**Work Order ID 85382**

# DART SERVICE INSTRUCTION

TO AMEND INSTALLATION INSTRUCTIONS  
IIN-D412-698 REV. E OR LATER APPROVED REVISION

REF. TCCA STC: SH92-43

**FIGURE 3: LOCATION OF D4330-042 AIRFRAME BRACKET ASSEMBLY**  
(RH Shown, LH Opposite)

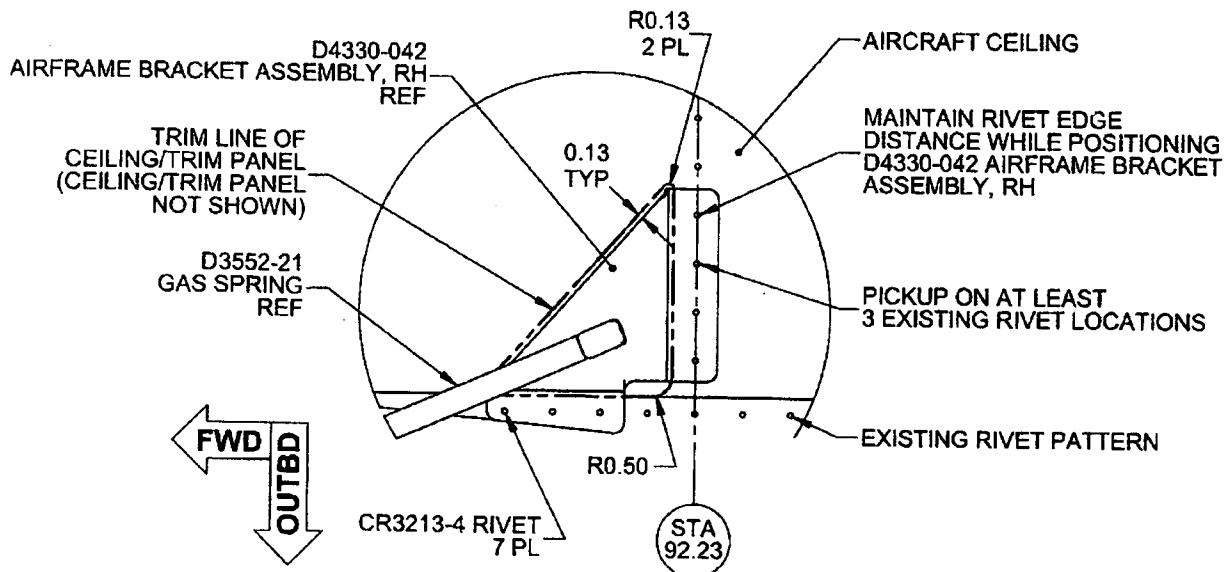
B	ADDED NOTE TO TRIM EXISTING TRIM/CEILING PANELS: ITEMS 11/12 OF SECTIONS 3.0/4.0 (SHT 2/4); UPDATED FIGURE 3 ACCORDINGLY. REF: PAR11-150.		
A	NEW ISSUE		
REV.	DESCRIPTION		
DESIGN	<u>JPC</u>	<b>DART AEROSPACE LTD</b> HAWKESBURY, ONTARIO, CANADA	
DRAWN	<u>1</u>		
CHECKED	<u>JWJ</u>	DRAWING NO.	REV. B
MFG. APPR.	N/A	DSI 9548	SHEET 1 OF 8
APPROVED	<u>MSP</u>	TITLE	SCALE
DE APPR.	<u>MSP</u>	HINGE DOOR OPENER KIT	NTS
DATE	12.01.17	COPYRIGHT © 2011 BY DART AEROSPACE LTD. THIS DOCUMENT IS PRIVATE AND CONFIDENTIAL AND IS SUPPLIED ON THE EXPRESS CONDITION THAT IT IS NOT TO BE USED FOR ANY PURPOSE OR COPIED OR COMMUNICATED TO ANY OTHER PERSON WITHOUT WRITTEN PERMISSION FROM DART AEROSPACE LTD.

11. Pre-install the ceiling or trim panels that were removed in Step 1 and transfer mark contour of D4330-041 or -042 as shown in Figure 3 (SHT 5). Remove ceiling or trim panels and perform cutout to clear D4330-041 or -042. Touch-up finish of ceiling or trim panels cutout area in accordance with aircraft maintenance manual and re-install any ceiling or trim panels.
